CITY OF ALBUQUERQUE

**RE: 1424 Caballero Drive SE
Grading and Drainage Exhibit
Stamp Date 8-4-2016 (File:M23D008A)**

DRAINAGE AND TRANSPORTATION INFORMATION SHEET (REV 1/2016)

NORTH
GRADING AND DRAINAGE PLAN
SCALE: 1"=10'-0"

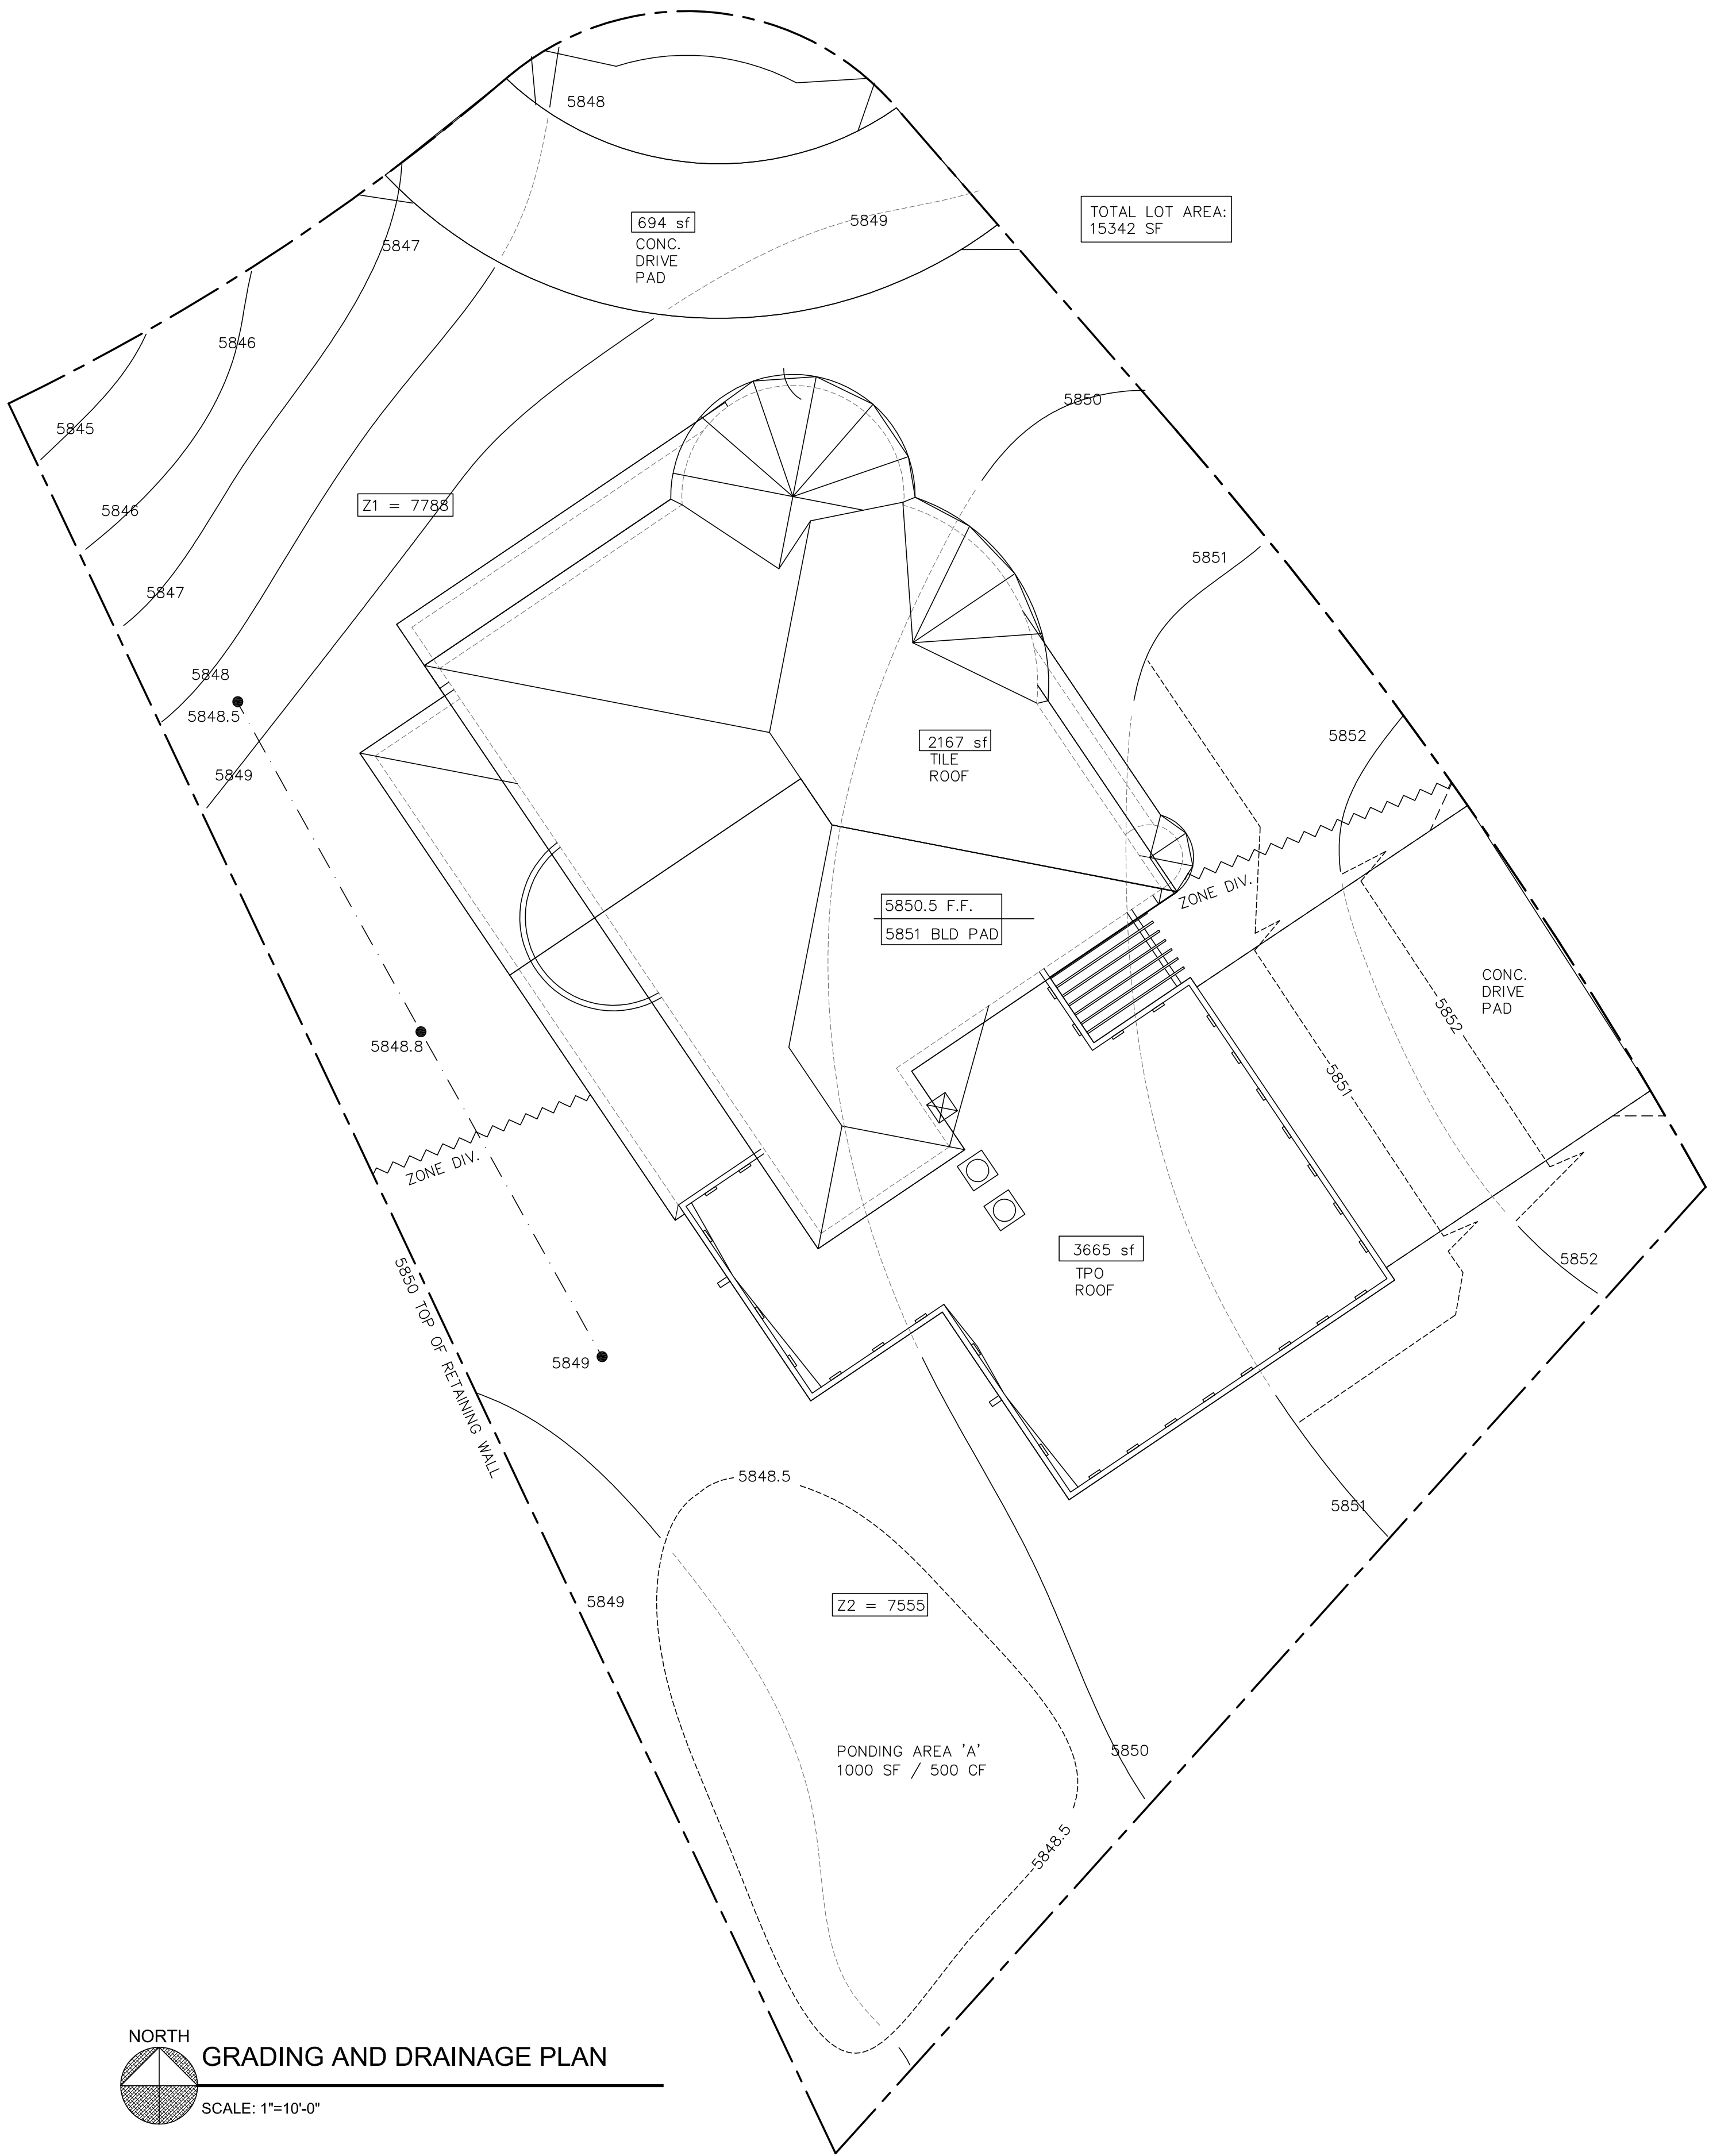
Based on the exhibit, we understand that a small pond is planned at the southern corner of the lot. This pond appears to only capture a portion of the additional runoff generated by the site, and it is unclear if the peak discharge is mitigated. However, based on the proposed retaining wall elevation and the swale shown, the remaining runoff appears to be directed to the street. Please contact me if this is not the case.

Please also ensure that this concept is maintained through construction. If this general condition is not possible during construction, a submittal will be needed to show how the discharge will be handled without increasing the historical overflow into the adjacent property.
